MYSO, LLC
Response to Siting Board Staff's First Request for Information
Case No. 2025-00395

Cumulative Environmental Assessment

Mayfield Solar Project
Graves County, Kentucky

LANDSCAPE BUFFER LOCATIONS

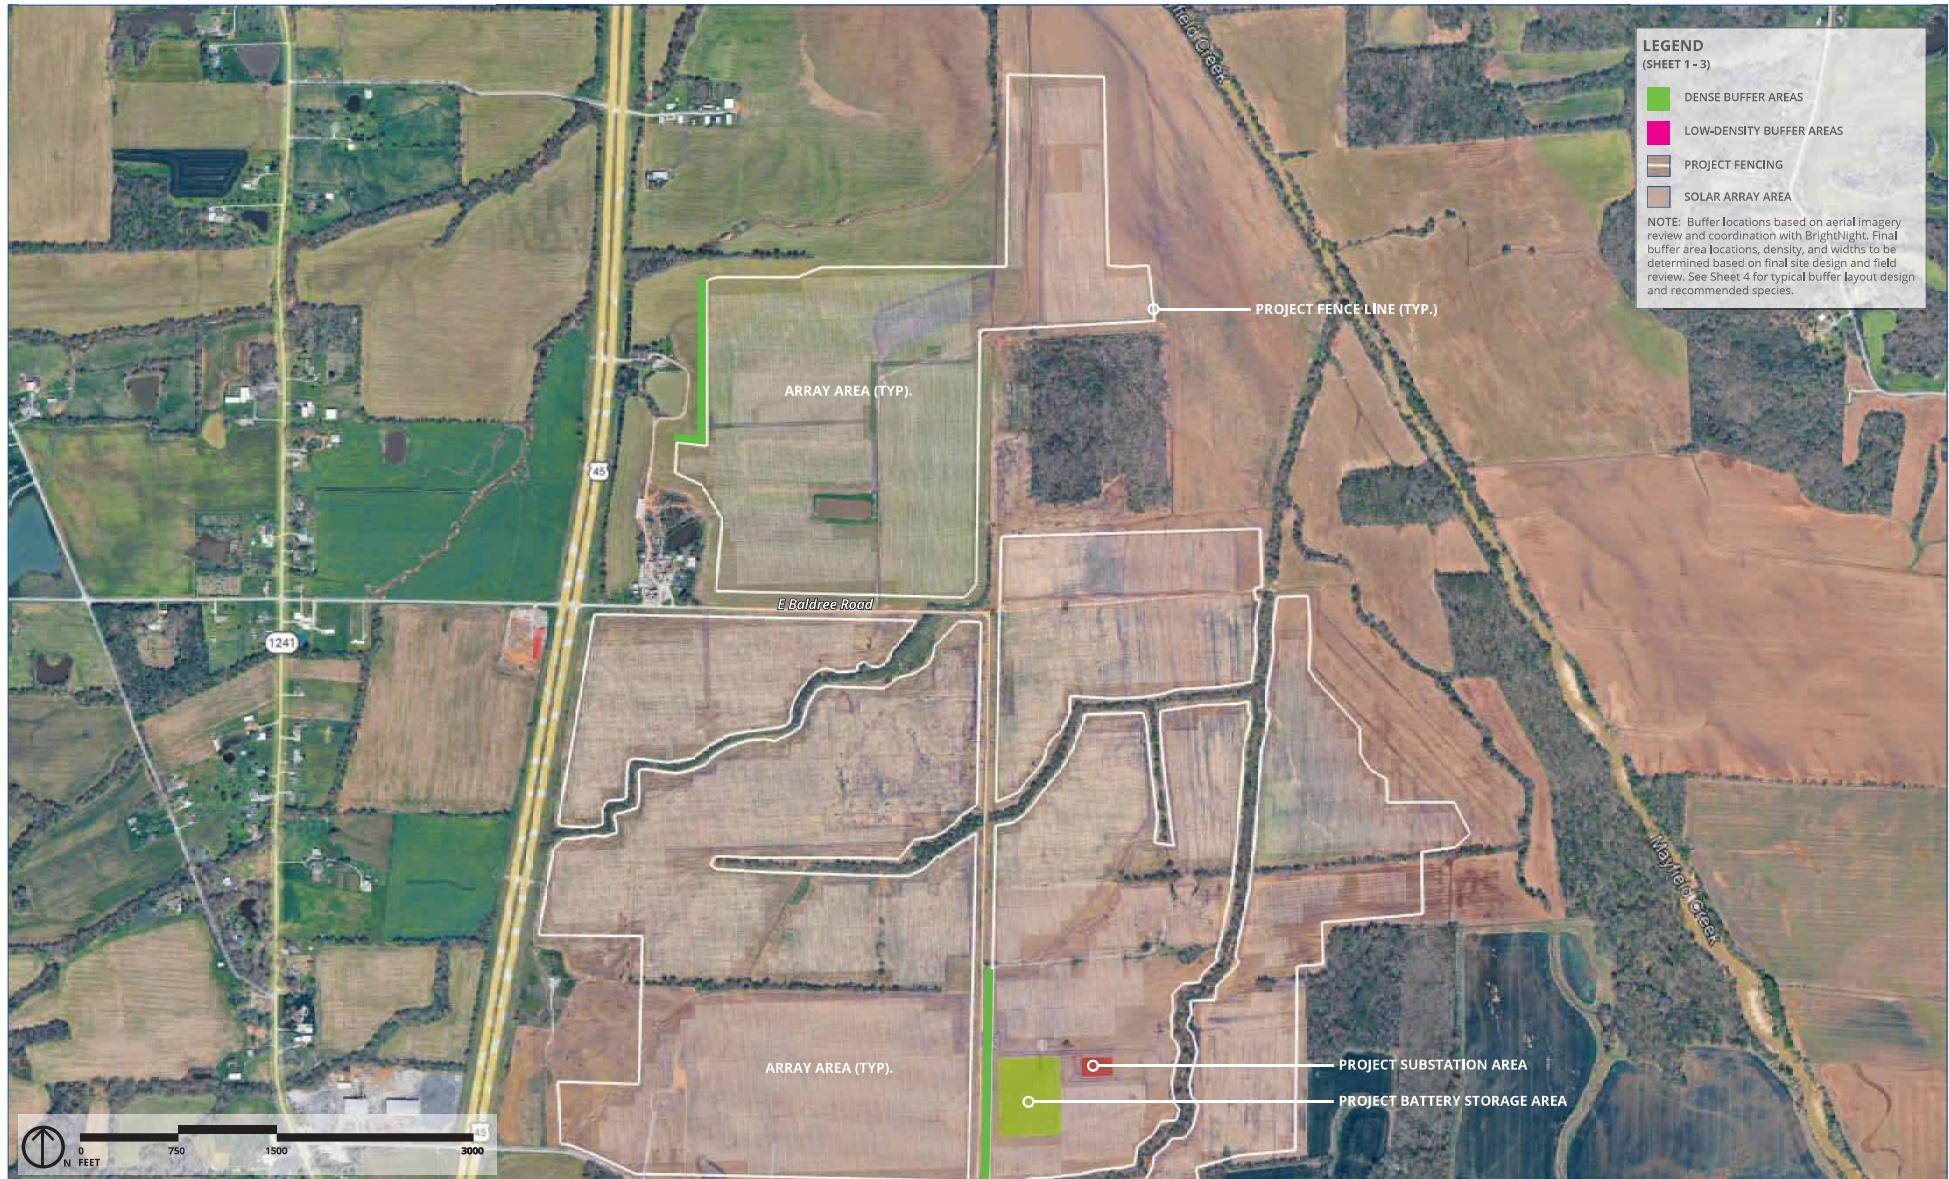
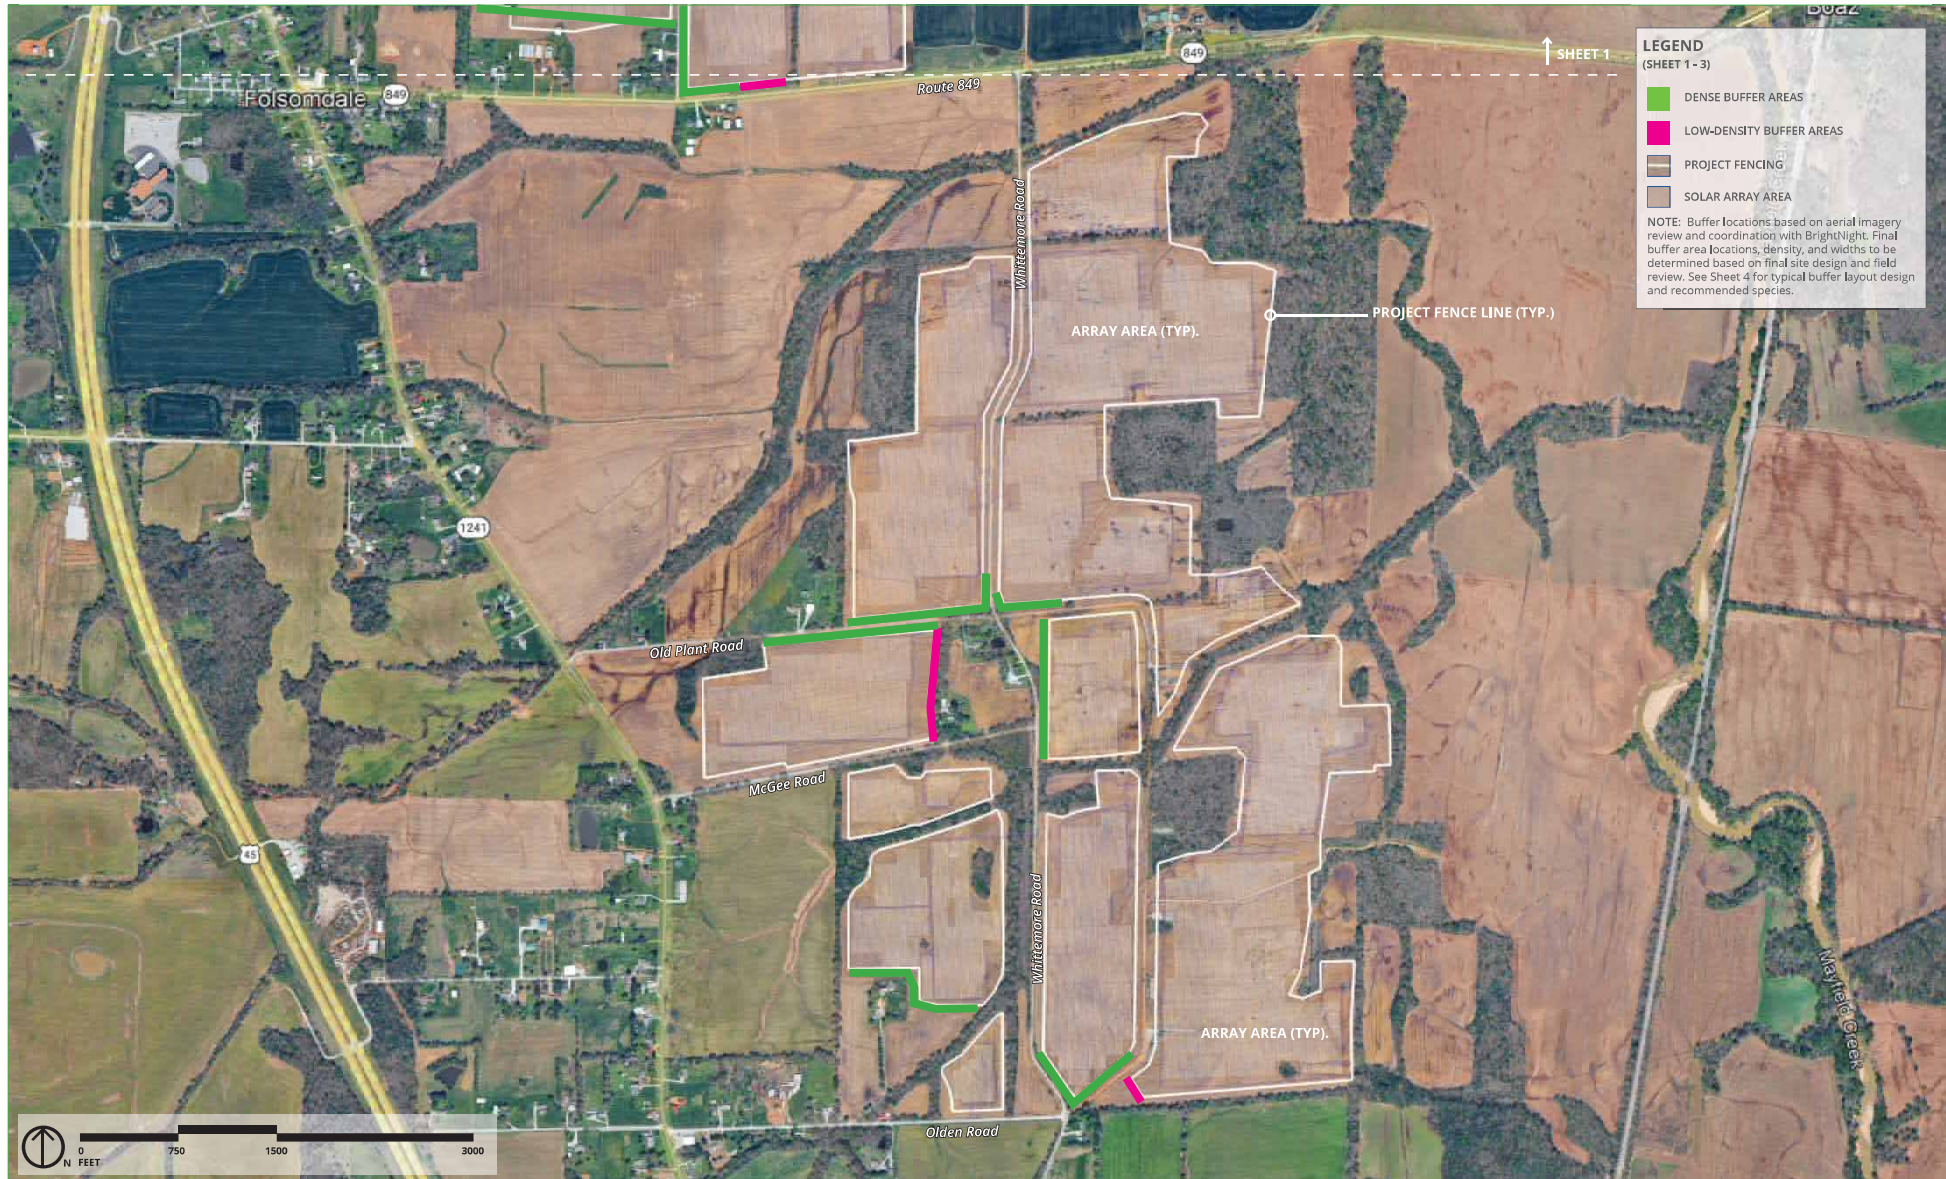
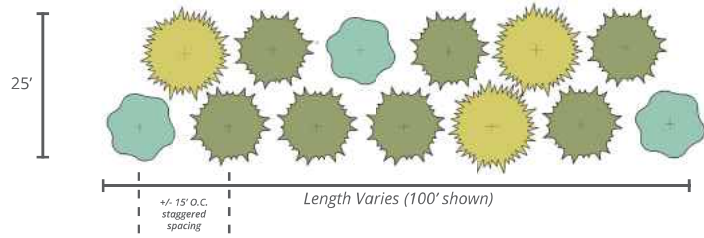
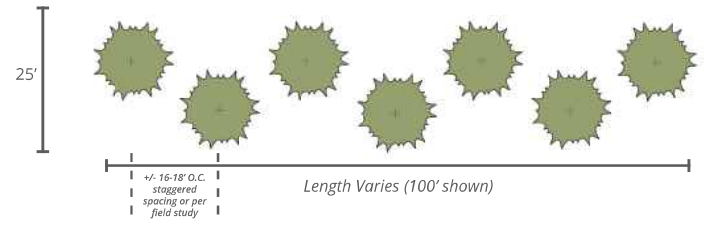
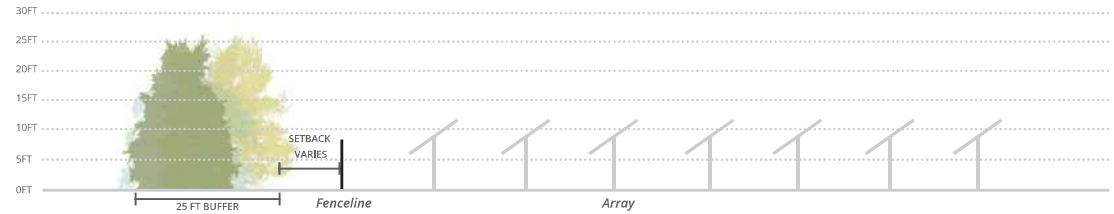
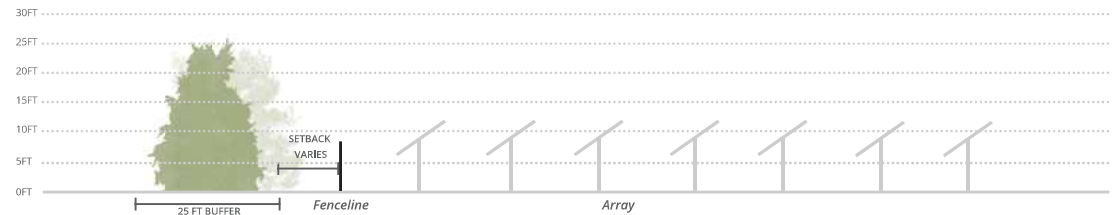
Refer to the Application, Description of Proposed Site, Item 12, specifically stating that the Project plans to install vegetative screening in key locations. Provide a detailed landscaping and screening plan. Include the following:

- a. Identifying the location of proposed screening,
- b. The basis for screening locations,
- c. The length of different segments of screening,
- d. The types of vegetation to be installed,
- e. Their height at maturity, length of time to maturity,
- f. Plans for on-going maintenance, and
- g. Other details related to the proposed screening.

Please see attached.

Intent:
This conceptual landscape buffer plan has been prepared as a guide for visual mitigation of the Mayfield Solar Project. Layout 1 provides a typical layout for a dense buffer applicable to Project view corridors where no existing intervening vegetation is present. Layout 2 provides a typical layout for a low-density, complementary buffer to enhance areas where some existing vegetation exists that may only partially screen the Project. Both layouts include evergreen species native or naturalized to Kentucky and have been selected to provide a more natural, varied appearance.

| DRAWING TITLE | TREE EXHIBIT |

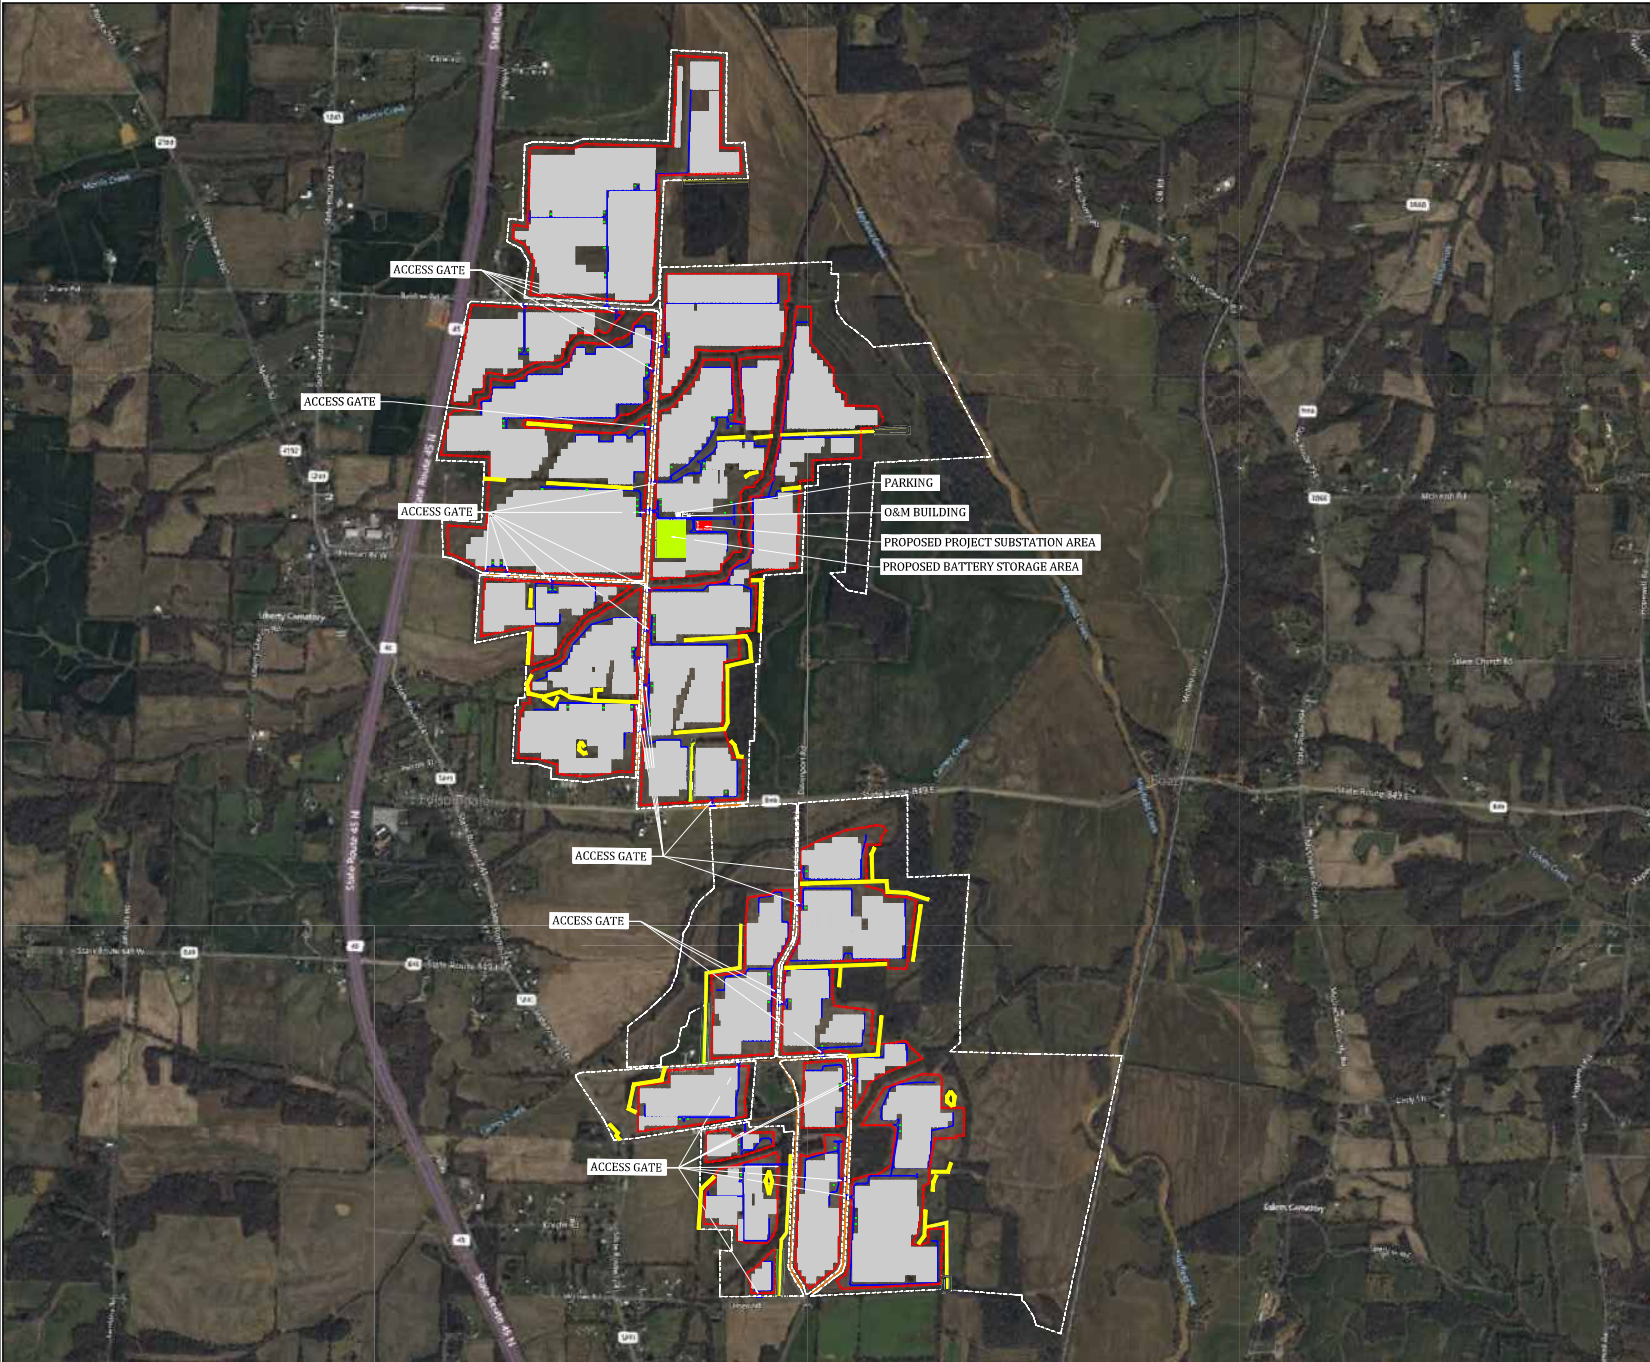
Refer to Exhibit H, SAR, Attachment A, Site Plan, listing a "tree trimming area" of about 81 acres.

Explain the planned tree trimming activity and identify the areas of tree trimming on a map of the site.

The planned tree trimming activity is for areas where tree shading may require trimming, topping, or removal of trees. Please see attached.

- TOTAL TREE TRIMMING CONSIDERED ~81 ACRES
- THERE IS NO TREE REMOVAL WITHIN ANY JURISDICTIONAL FEATURES (STREAMS/WETLANDS ETC)
